From: Helgardt Slabbert <helgardt@valumax.co.za>
Sent: Friday, September 11, 2020 2:39 PM
To: Vanessa Stippel
Cc: De Wet Botha
Subject: RE: 21637 | Notification of Public Review of EIA Report and WULA Technical Report | Proposed Development of Riverside View Extension 84, City of Johannesburg, Gauteng (GAUT 002/17-18/E2040)

ADDENDUM 1 | RESPONSE TO CITY OF JOHANNESBURG IMPACT ASSESSMENT AND COMPLIANCE MONITORING COMMENTS DATED 12 OCTOBER 2020

ADDENDUM 2 | RESPONSE TO GDARD'S COMMENTS DATED 26 OCTOBER 2020

Figure 7: Google Earth Imagery from April 2012

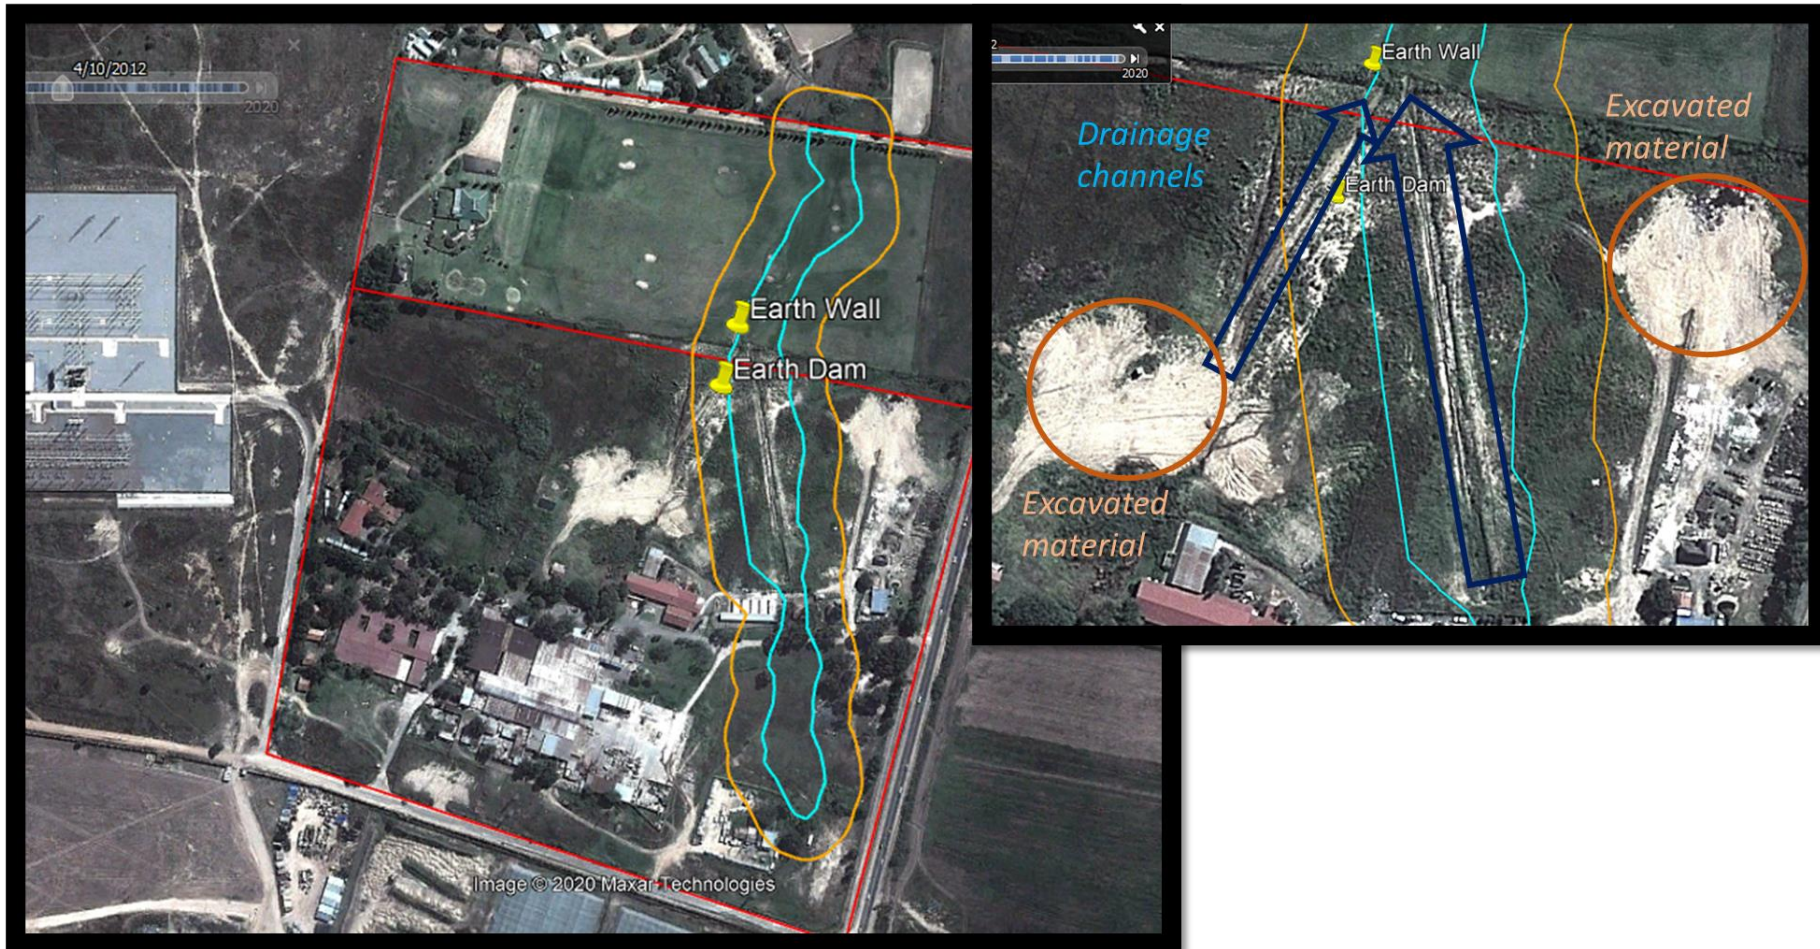
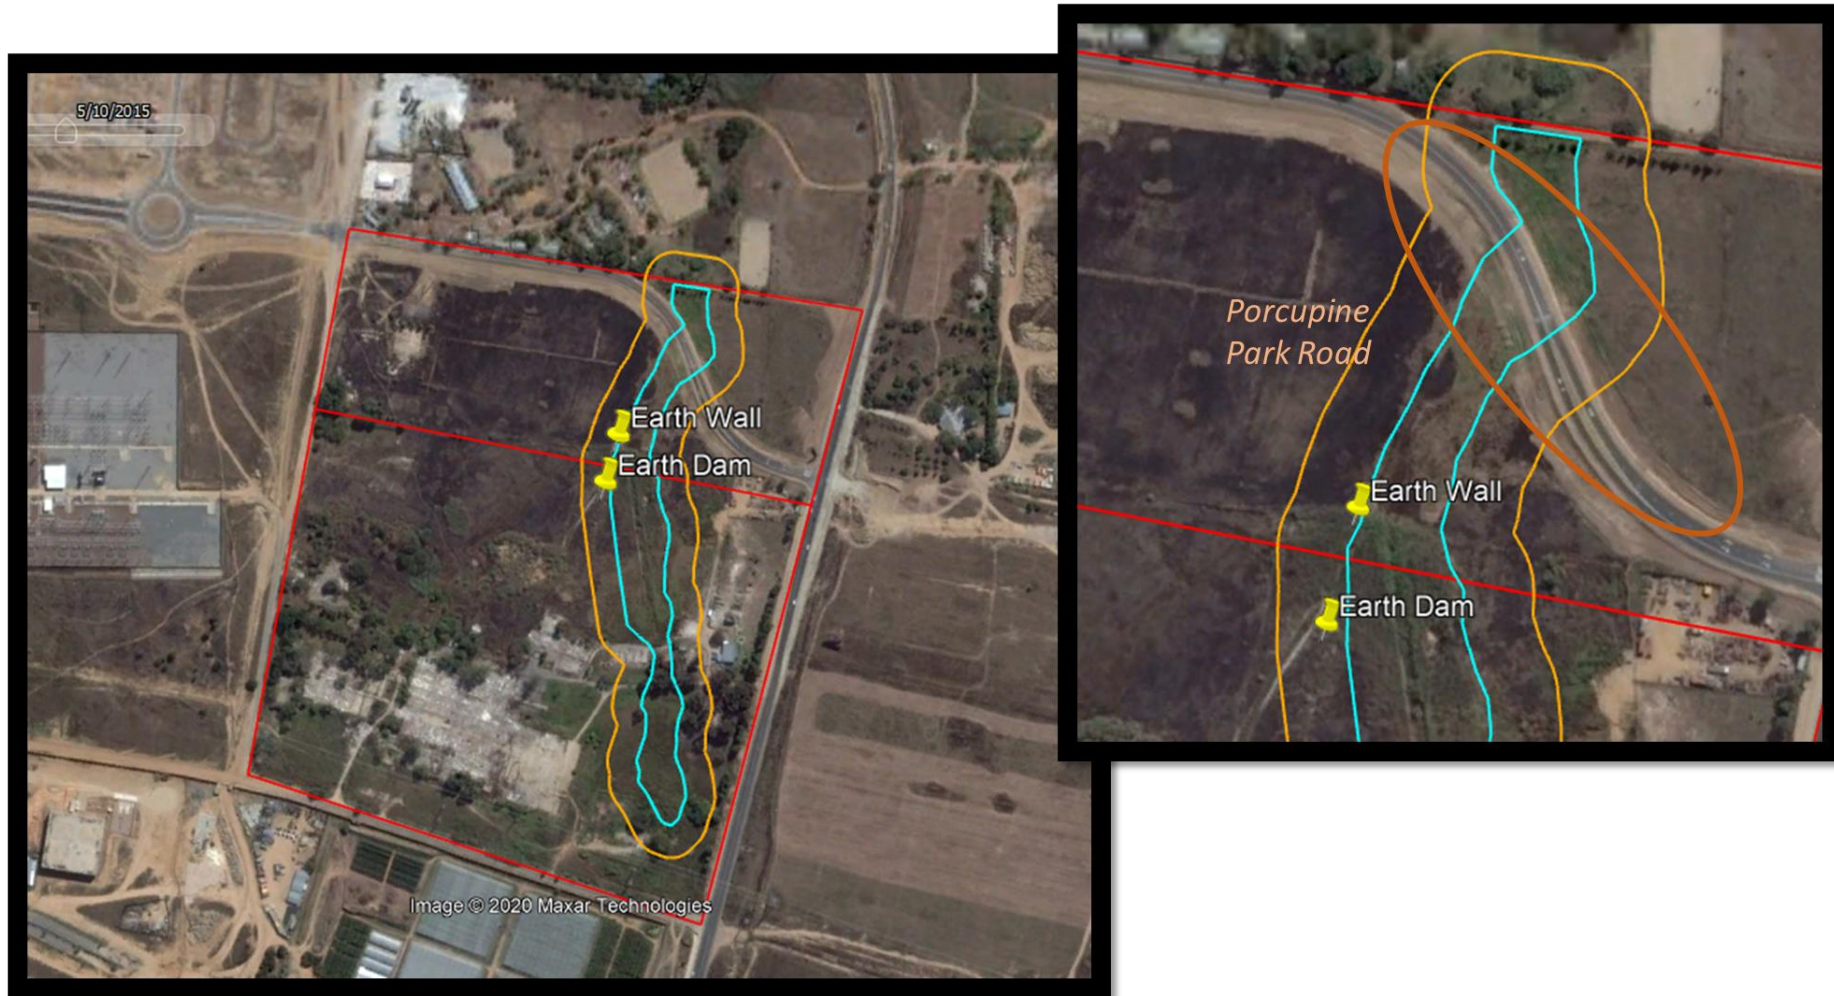
- Page 41 on wetland report indicated as figure 6.4 it display the wetland on site as per the Departmental Information System (GIS) but when its delineated on page 45 as figure 6.8 the other part which is on Erf 1 it's no longer delineated as wetland a clarity must be provided because even on site visit even the reeds were observed on that part.

Google Earth imagery has therefore been utilized to provide a summary of the historic use of the site and how this has affected surface water. The aim of this is to provide a timeline and to explain the current status of the site.

Please refer to **Figure 2, 3 and 4** below.

*“The general slope of the area is to the north with locally gradients towards the east and west due to a shallow stream channel running from south to north through the eastern part of the holding. **The drainage feature has been modified due to stormwater trenches, runoff from large concrete paved areas and septic tank drainage fields. A stormwater drainage ditch runs through the central part of the holding into an earth dam on the central northern boundary with the golf driving range. The shallow stream and dam areas will be prone to marshy conditions. Locally levelled platforms were created via cut to fill to accommodate the large paved areas and buildings.**”*

*The northern parts of the site have been left fairly undisturbed apart from the **shallow dam in this area**. The school on the western part comprises of classrooms, sports fields and open veldt area to the north. The Lulamisa Eskom Substation is situated directly adjacent to the west of the property.”*
